UNITED STATES PATENT AND TRADEMARK OFFICE

Office Action Summary	Application No. 10/579,887	Applicant(s) STARK ET AL.	
	Examiner RYAN J. WALTERS	Art Unit 3726

The following title is suggested: METHOD OF MANUFACTURING A LIGHTWEIGHT VALVE.

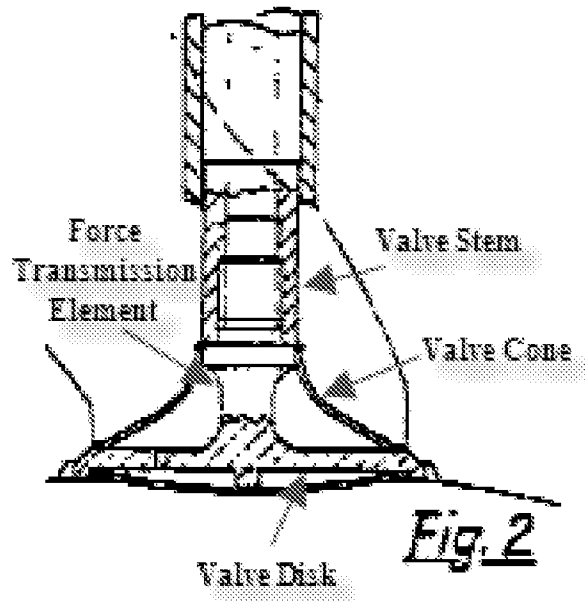
15. Re **Claim 21**, discloses a method for manufacturing a lightweight valve with a valve stem,

the valve disk also having a force transmission element extending through the hollow valve cone into the stem hollow space (Fig. 2),

forming the valve disk with the force transmission element by casting, forming and/or a powder metallurgy method;

non-positive and/or positive connection (Fig. 2; page 2 of translation).

16. Re **Claim 22**, Schwaiger discloses the second component is a one-piece component (Fig. 2; page 2 of translation).
17. Re **Claim 23**, Schwaiger discloses the force transmission element projects in a dome-like manner above a flat side of the valve disk facing the valve cone (Fig. 2).
18. Re **Claim 24**, Schwaiger discloses the force transmission element is arranged centrally on the valve disk (Fig. 2).
19. Re **Claim 25**, Schwaiger discloses the stem hollow space is provided with an axial stop against which the force transmission element is applied with an end face (Fig. 2).
20. Re **Claim 26**, Schwaiger discloses the axial stop is a fully circular shoulder (Fig. 2).

21. Re **Claim 27**, as best understood, Schwaiger discloses the stop has a surface extending at right angles or in a direction at right angles to a longitudinal central axis of the valve stem (Fig. 2).

23. Re **Claim 29**, Schwaiger discloses a free end of the force transmission element is inclined (Fig. 2).

24. Re **Claim 30**, Schwaiger discloses the free end is tapered (Fig. 2).

25. Re **Claim 31**, Schwaiger discloses the force transmission element has a bearing surface extending in a direction of a longitudinal central axis of the force transmission element and bears flat against a correspondingly designed countersurface of the stem hollow space (Fig. 2).

26. Re **Claim 32**, Schwaiger discloses the bearing surface also bears against an inner wall of the hollow valve cone (Fig. 2).

27. Re **Claim 33**, as best understood, Schwaiger discloses the bearing surface is fully circular (Fig. 2).

28. Re **Claim 34**, Schwaiger discloses the countersurface is provided with at least one recess for forming a positive connection between force transmission element and valve stem (Fig. 2).

29. Re **Claim 35**, as best understood, Schwaiger discloses the recess is fully circular (Fig. 2).

30. Re **Claim 36**, Schwaiger discloses the force transmission element has an end face with a blind hole (Fig. 2).

31. Re **Claim 37**, Schwaiger discloses the valve cone is formed by a tulip-shaped widening of the end of the valve stem (Fig. 2).

32. Re **Claim 38**, as best understood, Schwaiger discloses a connection between the force transmission element and valve stem is designed so that forces acting on the valve disk during operation are introduced essentially completely via the force transmission element into the valve stem (Fig. 2, page 2 of translation).

33. Re **Claim 39**, Schwaiger discloses the valve disk has a supporting portion against which the valve cone bears flat in sections in an end region of greater diameter (Fig. 2).
